ADF4371

Product Change Notification Support Data

Typical Jitter Performance (1KHz to 100MHz)

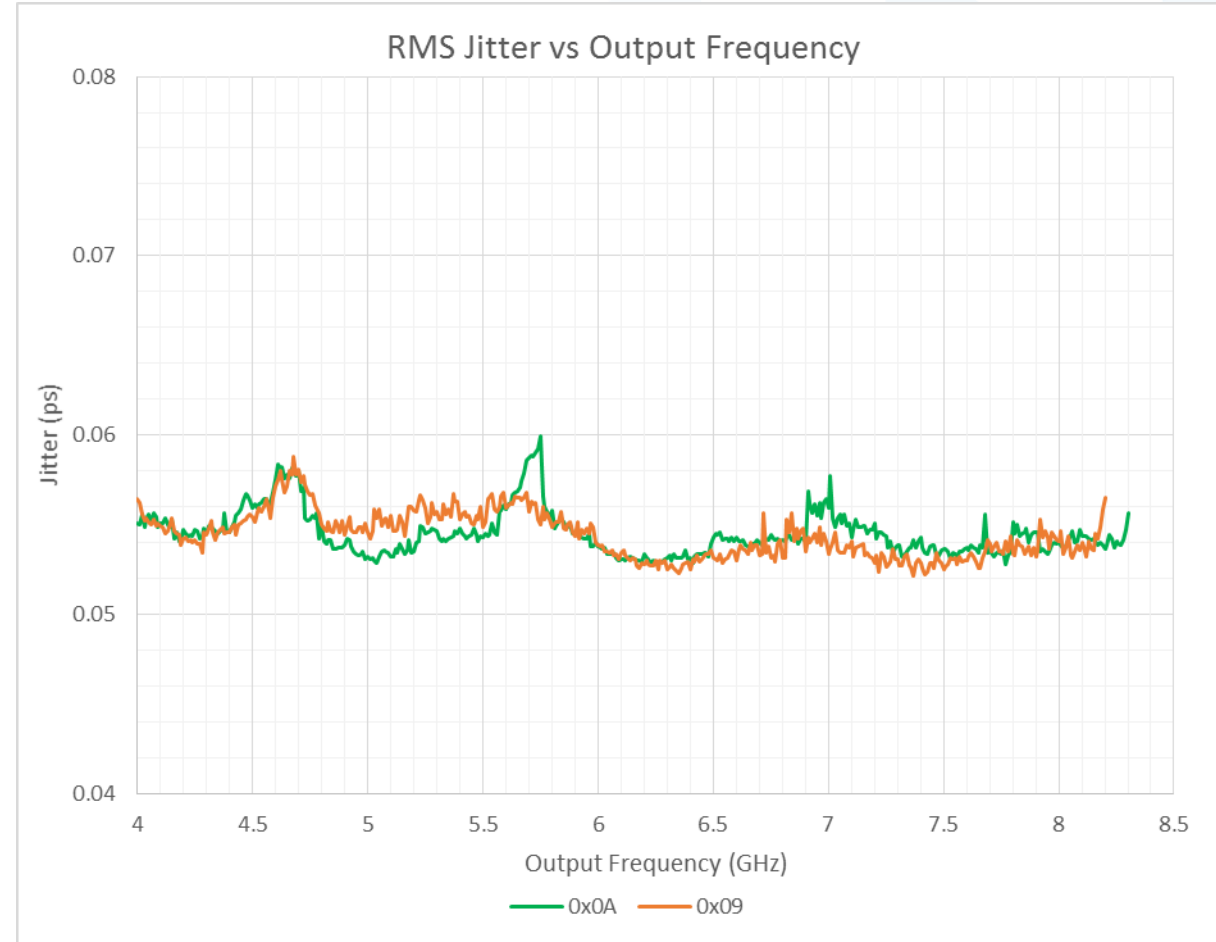
No significant change from current revision to new revision

Typical PFD Spurs

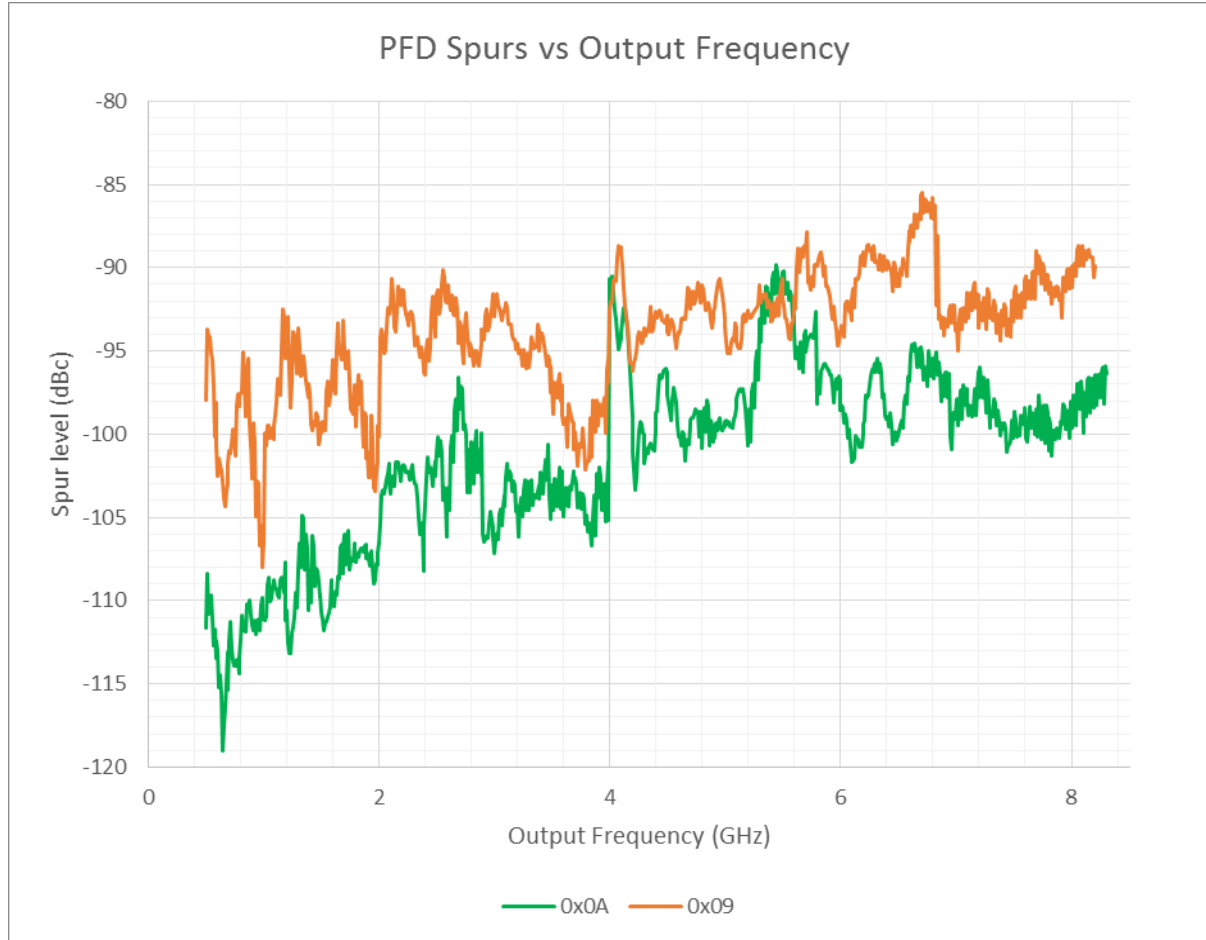
- ▶ The **0x0A** new revision silicon has some slight improvements over current **0x09** revision material:
 - Spurs: An improvement in typical spur performance achieved. (see plots below)

No deterioration from current revision to new revision – slight improvement
